**To:** Members of Dublin City Council  
**From:** Dana L. McDaniel, City Manager */MAC/dm*  
**Date:** October 15, 2018  
**Initiated By:** Vincent A. Papsidero, FAICP, Planning Director  
Claudia D. Husak, AICP, Senior Planner/Current Planning Manager  
**Re:** Basic Plan – Bridge Park Block G – (Case#18-061BPR)

18-061BPR  
Basic Plan Review  
Bridge Park  
Block G

block g | **bridge park**  
basic site plan submittal | **september 12, 2018**

CITY OF DUBLIN, FRANKLIN COUNTY, OHIO  
**BASIC PLAN**  
 FOR  
**BRIDGE PARK**  
**BLOCK G**  
 2018

CITY OF DUBLIN, FRANKLIN COUNTY, OHIO  
BASIC PLAN  
FOR  
**BRIDGE PARK  
BLOCK G**  
SITE PLAN

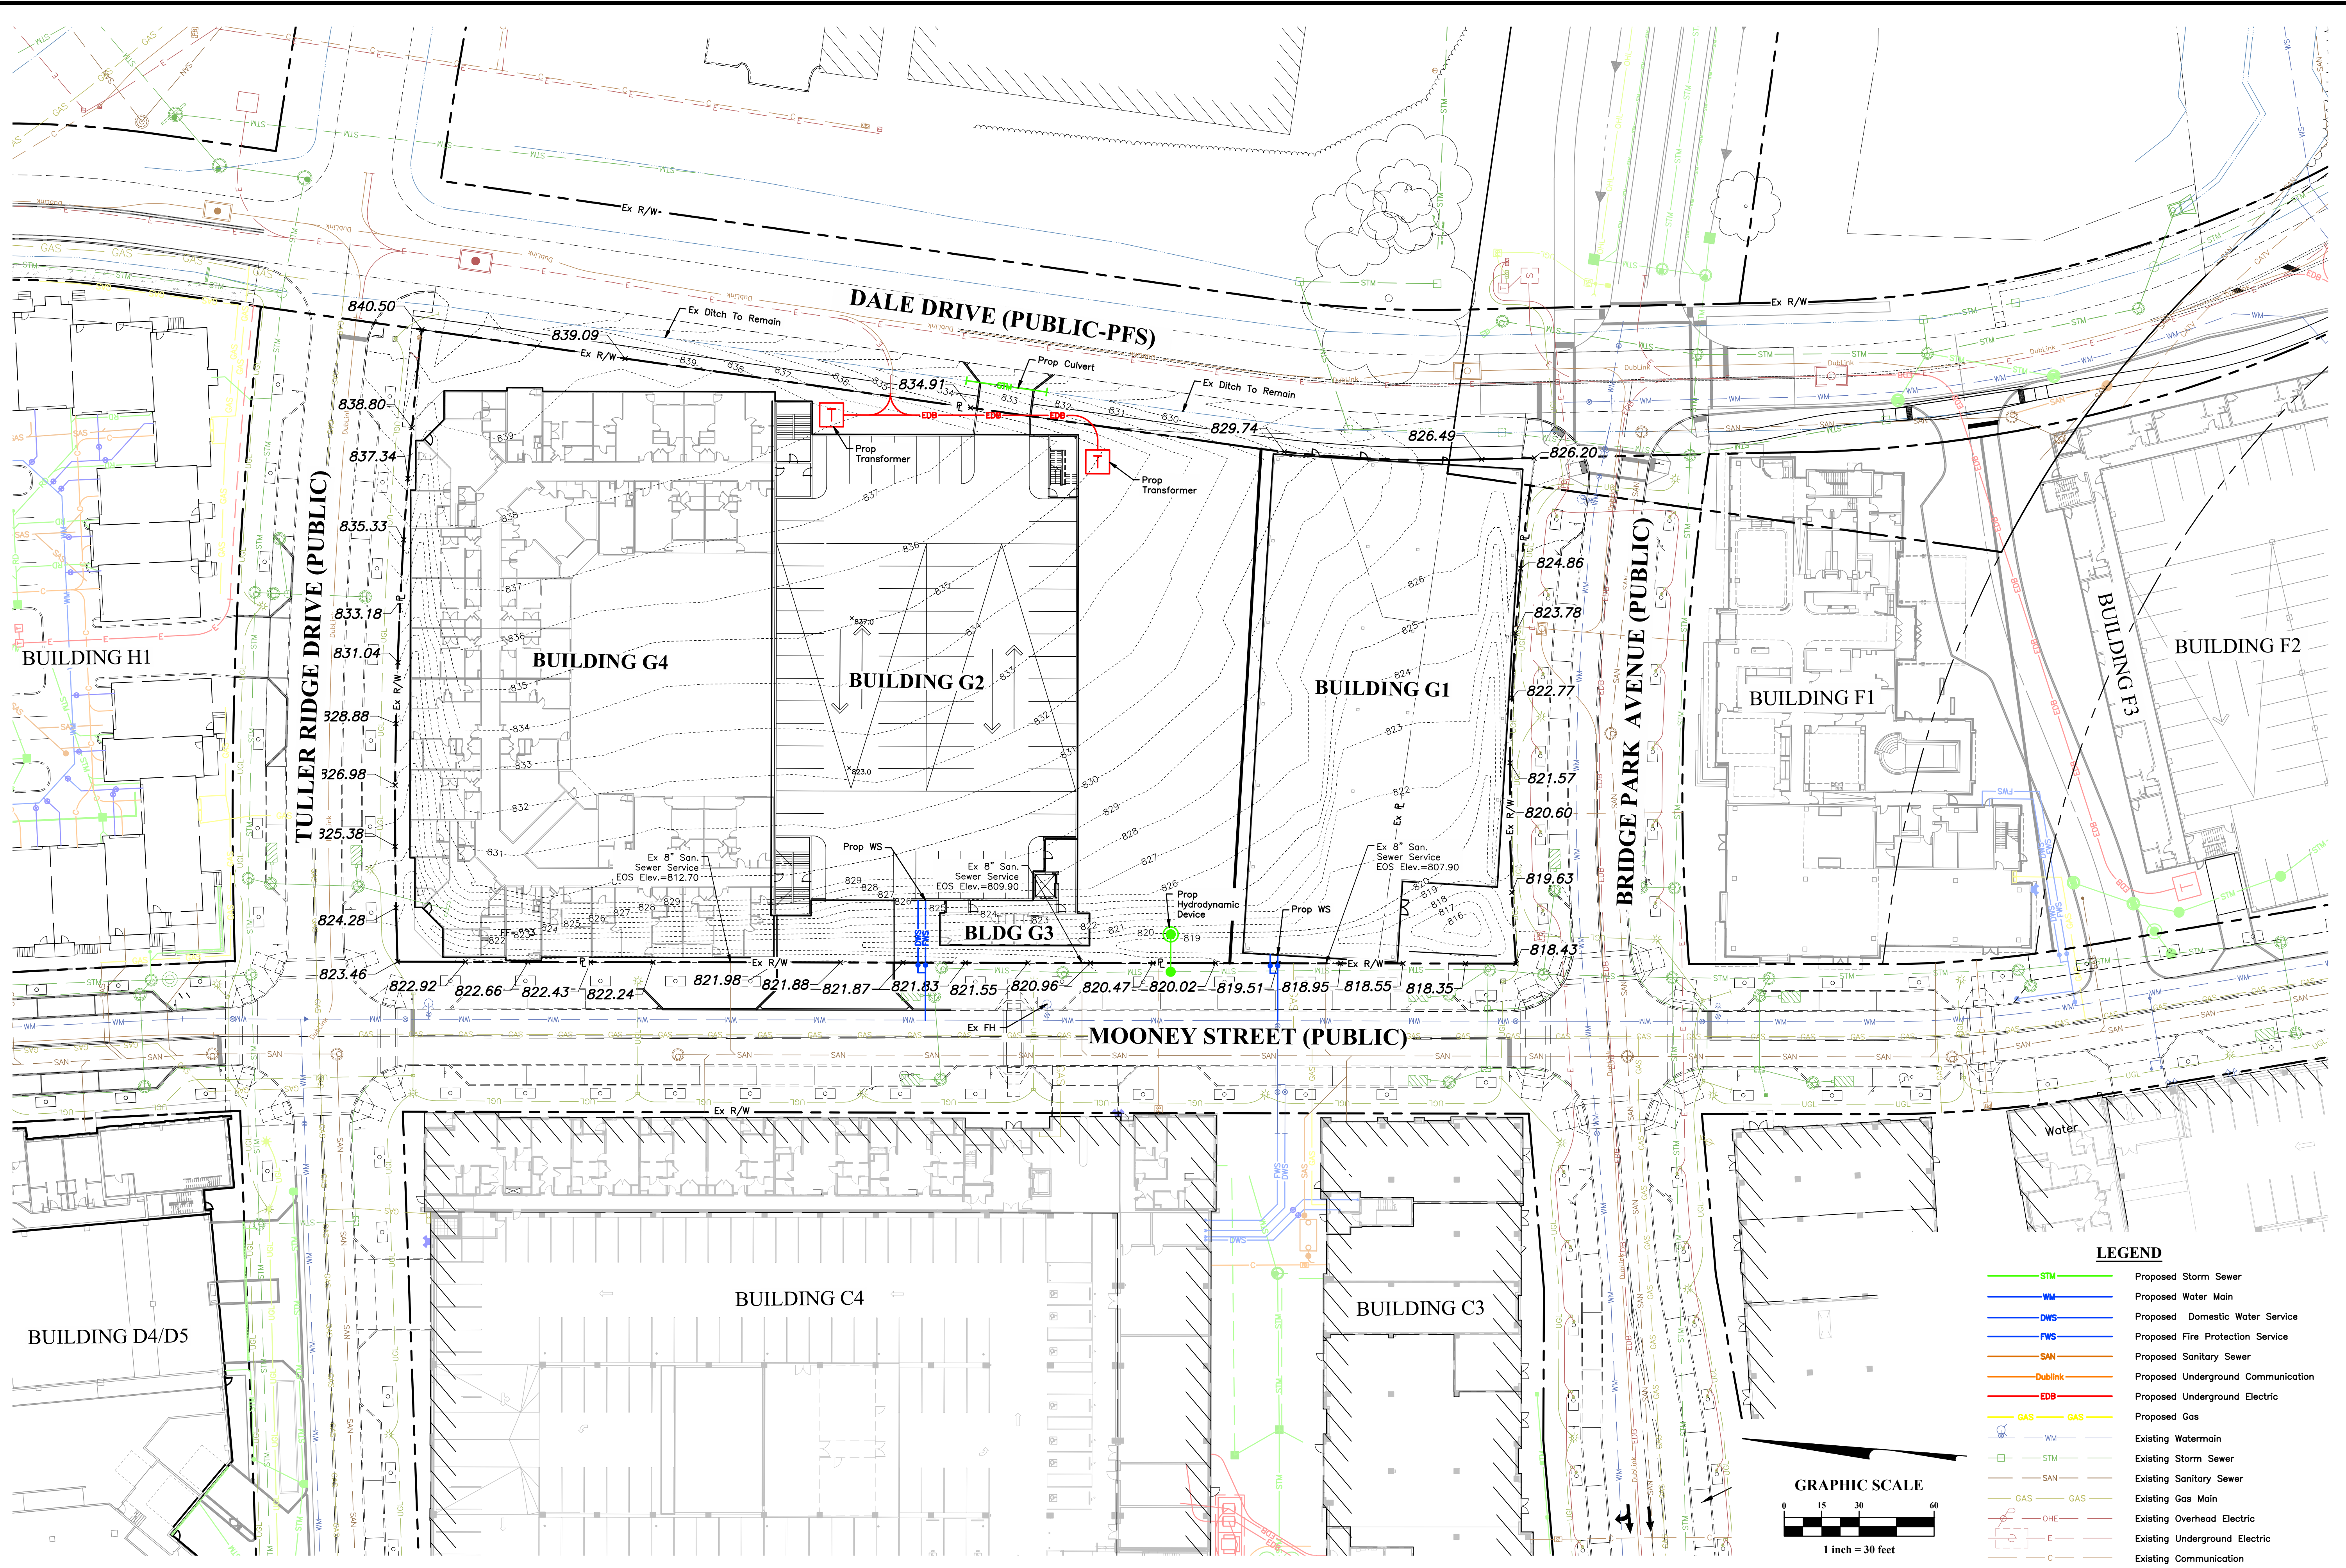
- 3) That the proposed design of the plaza and streetscape extension adjacent to Building G1 be revised to meet Code to provide adequate pedestrian space;

- 6) That the setback along the shopping corridor along Bridge Park Avenue meet Code requirements; and,
  - 7) That the applicant revise the plans to eliminate door swings into the ROW.
- 3) Determine the required reviewing body determination for future Development Plan Review and Site Plan Review applications (CC, PZC, or ART).

A minimum of 12 feet of clear sidewalk width is required along designated shopping corridors. Bridge Park Avenue is a designated shopping corridor. The proposed design of the plaza and streetscape extension adjacent to Building G1 provides appears to provide less than the requirements and should be revised to meet Code.

Criteria not met. The building can be shifted to the south to meet the required building zone placement to provide the minimum 5 feet of separation of parking structures from the right-of-way.
